**UNITED STATES  
NUCLEAR REGULATORY COMMISSION  
ADVISORY COMMITTEE ON REACTOR SAFEGUARDS  
WASHINGTON, DC 20555 - 0001**

SUBJECT: ACRS ASSESSMENT OF THE QUALITY OF SELECTED NRC RESEARCH  
PROJECTS - FY 2016

# **Assessment of the Quality of Selected NRC Research Projects by the Advisory Committee on Reactor Safeguards - FY 2016**

**Figure 2 – Crack Growth Rate Test Data from NUREG/CR-7184 Compared to Prior Disposition Curve for Cast (CF) Materials in PWR or Low Dissolved Oxygen (DO) Environments (A, B, N1, etc. refer to Test Specimens)**

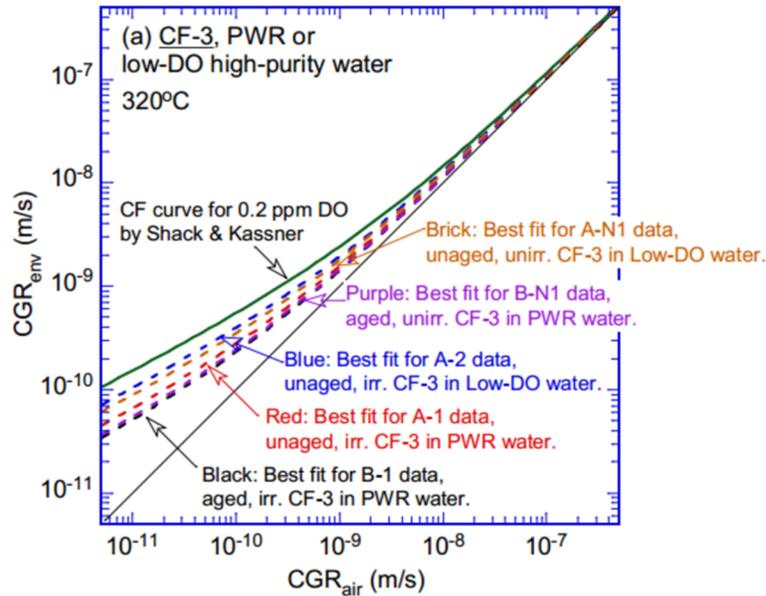
The research results are illustrated in Figures 2 and 3. Figure 2 shows that, while some environmental effects on crack growth rates (CGRs) are seen in the new data, the CASS material continues to exhibit good resistance to both corrosion fatigue and SCC before and after thermal aging and irradiation, and is bounded by a prior bounding curve for environmental effects (e.g., the Shack & Kassner CF curve from NUREG/CR-6176 [19]). The toughness

The report discusses scatter and uncertainty in the crack growth rate data in several places, stating that, “given the large scatter of the data sets and the inherent uncertainty in short-duration CGR tests like these, the difference is statistically insignificant”. However, no such statement is made with regard to the fracture toughness testing. While scatter in toughness testing is generally less than that in CGR tests, it is not insignificant, and the post-irradiation differences (brick-colored bars in Figure 3) between irradiated-unaged and irradiated-aged toughness are not very large (20-30%). These stated differences are exaggerated by the fact that the report presents toughness in terms of J-Integral, which in a pure sense is proportional to the fracture toughness,  $K_{Jc}$ , squared. Including this square root effect, the actual difference in measured toughness should be reported as 9-14%, which is well within the expected scatter band of fracture toughness

**Figure 3 – Fracture Toughness Data from NUREG/CR-7184 Illustrating Toughness Reduction Observed due to Thermal Aging and Irradiation Embrittlement of Various Grades of Cast (CF) Materials**

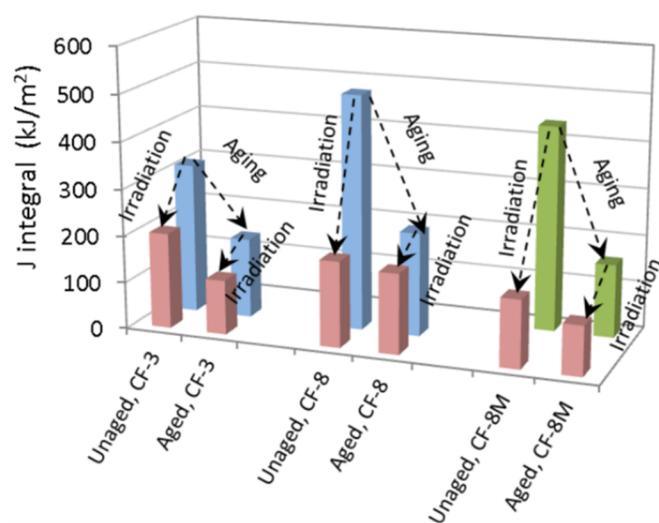
reduction effect illustrated in Figure 3 shows that both neutron irradiation and thermal aging, acting alone, produce significant reduction in toughness. The report argues that the combined effect of thermal aging and irradiation damage can reduce the fracture resistance of CASS to a greater extent than either effect alone (right-hand, brick-colored bars in the figure). However, as discussed in the Quality Assessment section below, we question the statistical validity of this observation.

testing. Thus, data do not substantiate the report’s most significant finding, “The combined effect of thermal aging and irradiation damage can reduce the fracture resistance of CASS to a higher extent than any one of them can achieve alone.” It is based on just one test per material grade, and the small toughness differences observed between irradiated-unaged and irradiated-aged material could easily be overwhelmed by experimental uncertainty.

Another unaddressed uncertainty concerns the irradiation levels to which the samples were exposed (0.08 dpa). This fluence level is extremely low relative to doses experienced by CASS materials in reactor internals. Testing at this low fluence level is considered meaningful for initial scoping, since damage to the ferrite microstructure is expected to occur at relatively low fluence. However, the report doesn’t discuss whether the results represent a saturated condition or whether increased neutron exposure could lead to further damage. ACRS has subsequently learned that irradiation of additional samples is continuing in the Halden reactor, to higher fluence levels (3 dpa), which will be tested in the future. This is significant and should have been discussed in the NUREG/CR.
